LOWER FALLS IMPROVEMENT ASSOCIATION RIVERSIDE COMMITTEE

PRESENTATION TO THE ZONING AND PLANNING AND LAND USE COMMITTEES

September 23, 2019

Slide 2 shows the entire site with three signalized intersections at the perimeter, and two un-signalized intersections internal to the site, which are controlled by stop signs.

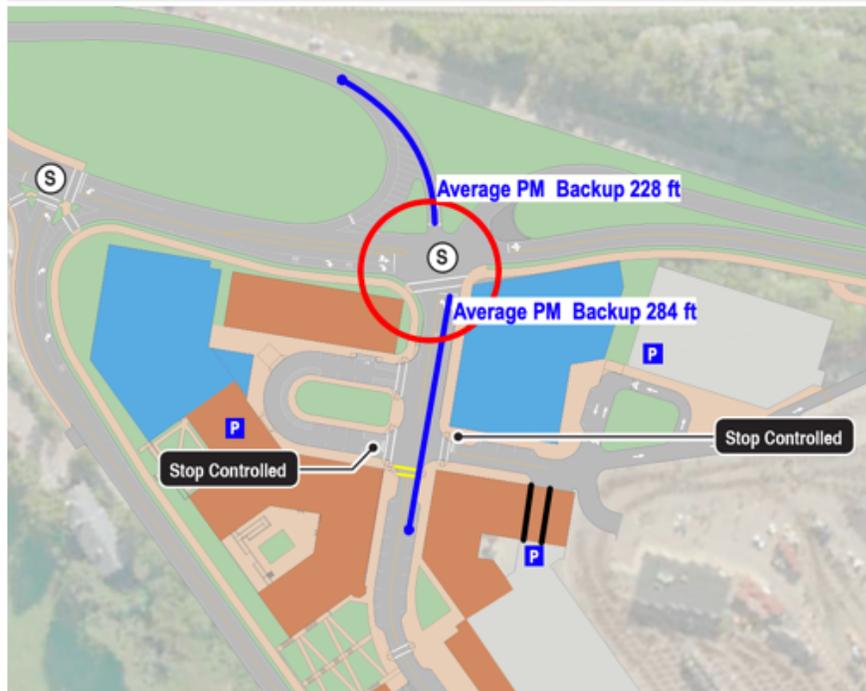
Analysis of external traffic: 'significant problems at multiple intersections.'

Slide 3 shows average backups blocking internal intersections leading to the main signalized exit from Riverside.

The average daily backup at the signal is 284 feet or about 19 car lengths.

Slide 4 shows traffic exiting Riverside will queue onto Main Street and block the cross street from the hotel and the garage serving the 8-story office building #3, and from the garage serving the 13-story office building #1.

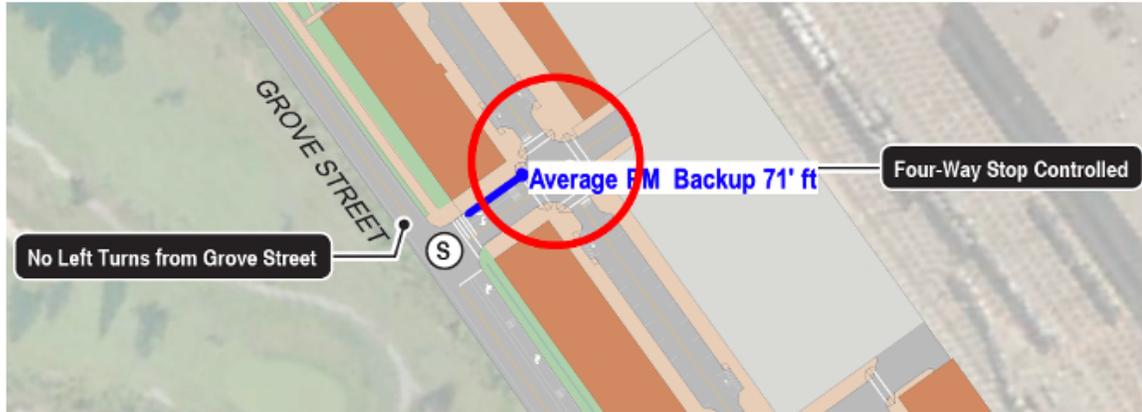
External study shows traffic exiting at ramp signal blocks 3 of 4 garages

Evening traffic exiting to Grove Street may obstruct 4-way stop intersection if TNC, GLT & game day traffic included

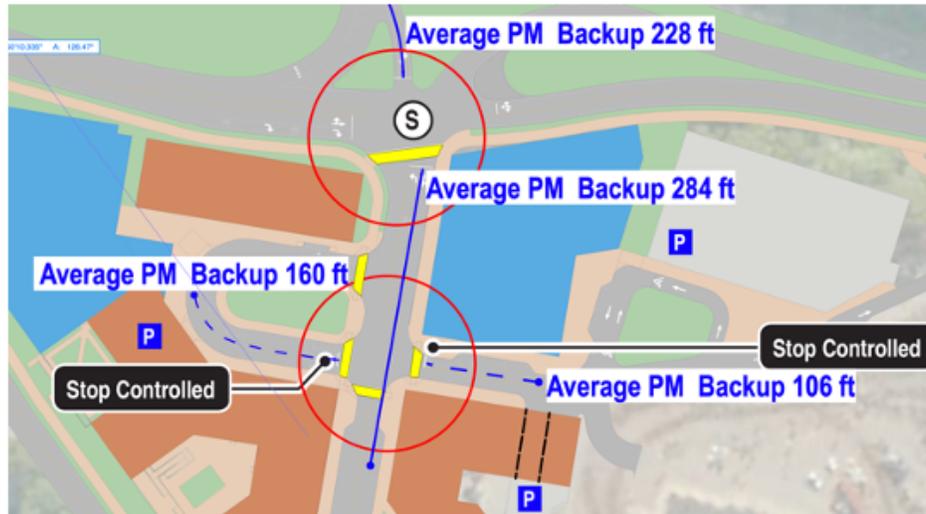
Slide 5 shows the backup at the exit directly onto Grove Street of 71 feet or about five car lengths. Just two more car lengths will block the crucial four-way stop at the center of the internal road system. When there is Red Sox game day traffic or if the Green Line Transformation project increases traffic volume to Riverside, blocking this intersection will become a regular occurrence with traffic backing up in the main garage building #9.

- Internal backups of 106 & 160 feet compound the external back up of 289 feet, trapping cars from exiting garage

Slide 6 shows the average queuing on the unsignalized cross street is 160 feet or 11 car lengths and 106 feet or 7 car lengths. Notice the dashed queues on the side street, are blocked by the solid queue on Main Street.

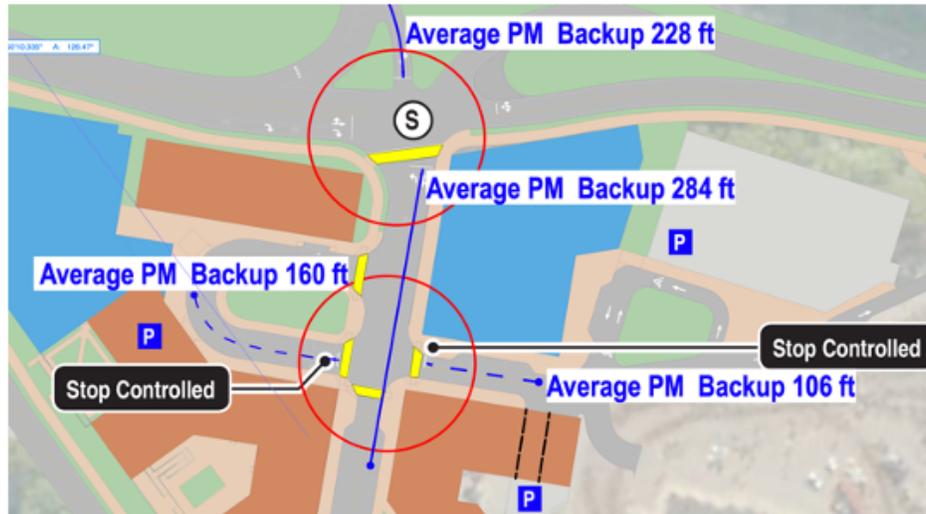
- ‘Shared parking’ will boost pedestrian travel across walkways, slowing vehicular egress

Slide 7 shows that there are 4 pedestrian walks that will surely make this scenario worse. Because there is shared parking across the site, there will be heavy foot traffic during rush hour. This will slow down the release of congestion.

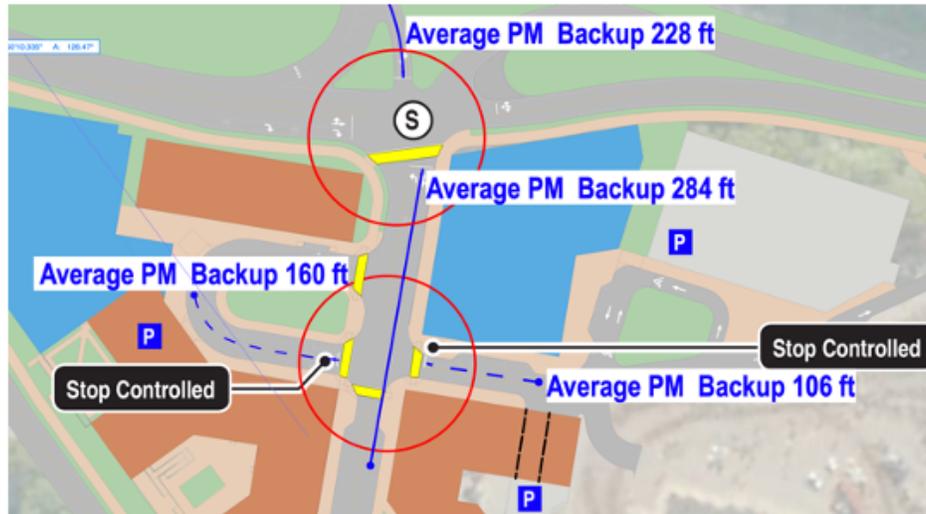
- ‘Shared parking’ will boost pedestrian travel across walkways, slowing vehicular egress

Slide 15: beneficial open space

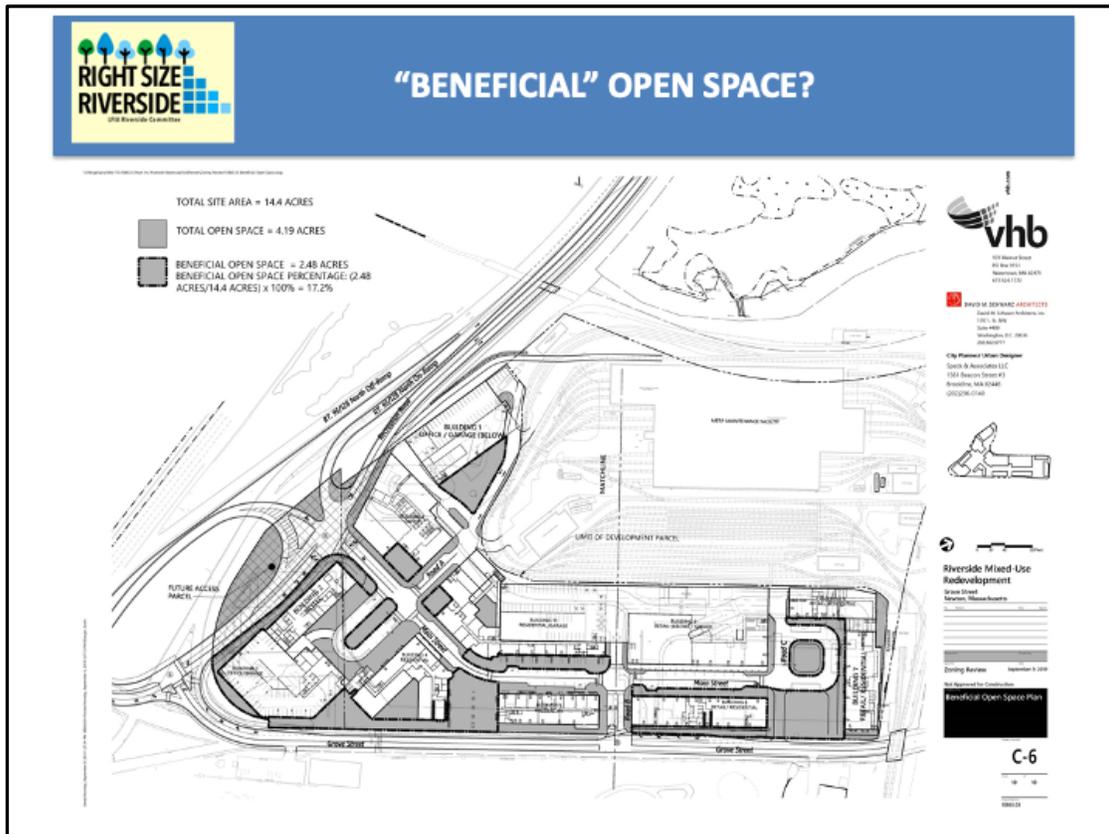
With respect to open space, weakness of the “beneficial open space” concept found in the current ordinance is on display, once again, in Mark Development’s revised filing. As you can see on this sheet from Mark Development’s new plans, to get to the 17% claimed beneficial open space, many of the areas included are just sidewalks or small left-over spaces around buildings.

Also, the quality of the claimed beneficial open space areas must be considered in light of the level of anticipated traffic within the site, including the space in the middle of what Mark Development calls transit square which is planned to be filled with MBTA buses, private buses, and shuttle vans as well as taxis, Ubers and private vehicles there for pick up and drop off.
